RESPONSE TO REQUEST FOR ADDITIONAL INFORMATION

US-APWR Design Certification

Docket No. 52-021

RAI NO.: NO. 850-6002 REVISION 3
SRP SECTION: 03.07.01 – Seismic Design Parameters
APPLICATION SECTION: 3.7.1
DATE OF RAI ISSUE: 10/21/11

Figure 1 – Regions of Marcellus and Devonian Shales

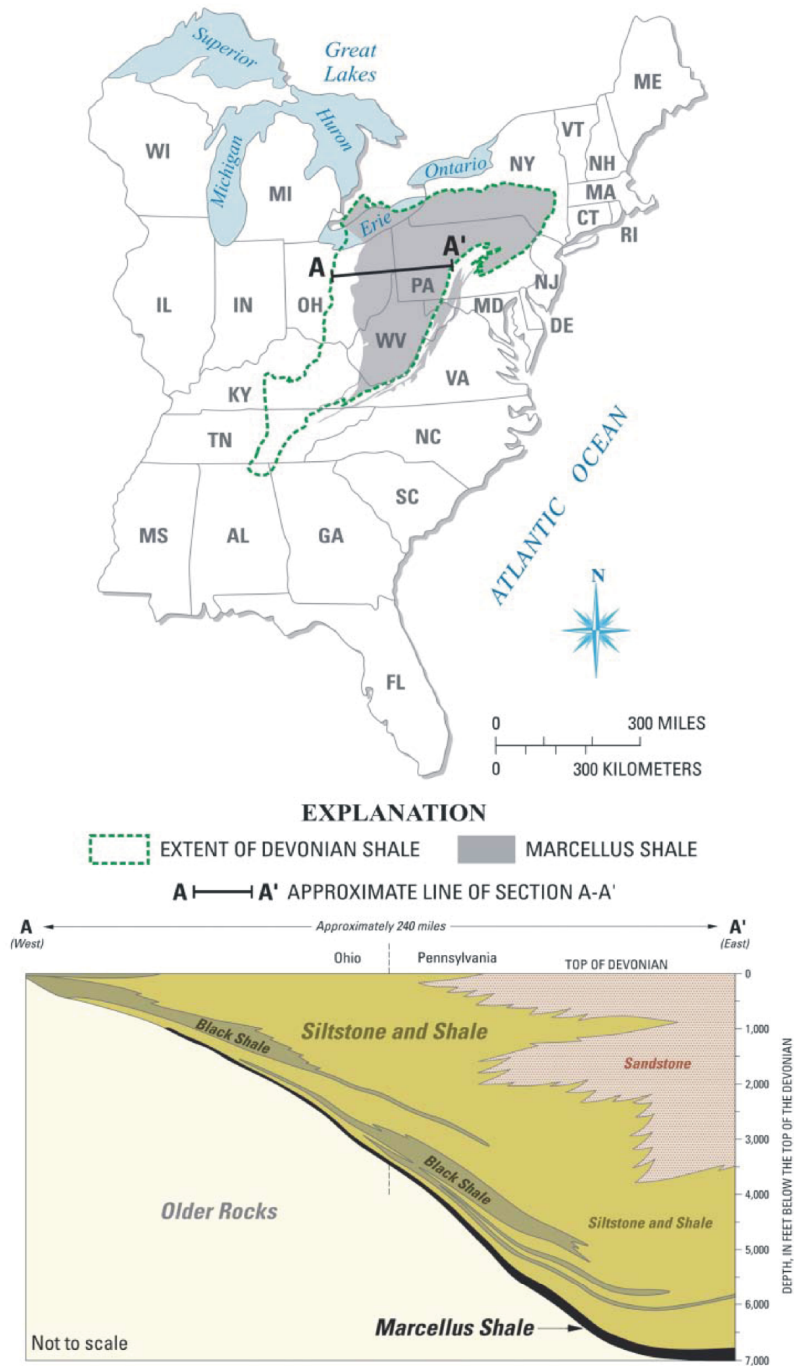
The staff believed that the US-APWR seismic analyses are to be applicable to a large number of sites in the Central and Eastern United States (CEUS), nonetheless, the reference cited (Reference 7) is meant for the Western US regions (specifically California). The Applicant is requested to explain: (1) how the material in Reference 7 in MUAP-10001(R3) is applied to the CEUS sites; and (2) describe the nature, extent, and the basis of the judgment that was necessary to determine the soil profiles that are applicable to and representative of the CEUS sites.

- (2) The soil/rock profiles as well as the soil degradation curves representing the soil stiffness (G/G_{\max}) and hysteretic damping as function of strain are generally similar between western North America (WNA) and central and eastern North America (CENA) because the geologic processes in North America do not change at 105° W longitude. Sands, clays, and gravels, Holocene soils, Pleistocene soils, soft, firm, and hard rock sites have similar dynamic material properties between WNA and CENA. It is only the relative distributions of these properties that differ. For example, loess and till sites exist in both WNA and CENA but with more concentrated in CENA. Similarly glacially showered sites are in WNA and CENA but again are more widespread in the CENA. Hard rock sites as well as hard rock beneath soils exist in WNA but are much more common in CENA. Residual and saprolitic soils exist across the U.S. but are more common in CENA. As a result, generic G/G_{\max} and hysteretic damping degradation curves are used worldwide and are not specific to any particular tectonic regime. The same tectonic independence applies to soil/rock velocity profiles with the exception of the differences in the occurrence of hard basement rock between WNA and CENA. Hard basement rock beneath soils is more prevalent in the CENA than in the WNA, however, there are also large regions across the CENA with significantly lower velocity sedimentary rock beneath the soils. As shown in Figure 1, the area comprising the Gulf Coast (EPRI, 1993, Reference 1) as well as the large region of the gas bearing Marcellus and Devonian shales, with both regions comprising a significant portion of the CENA, have sedimentary rock comprised of siltstones, sandstones, mudstones, shales, and some limestones underlying the soils.
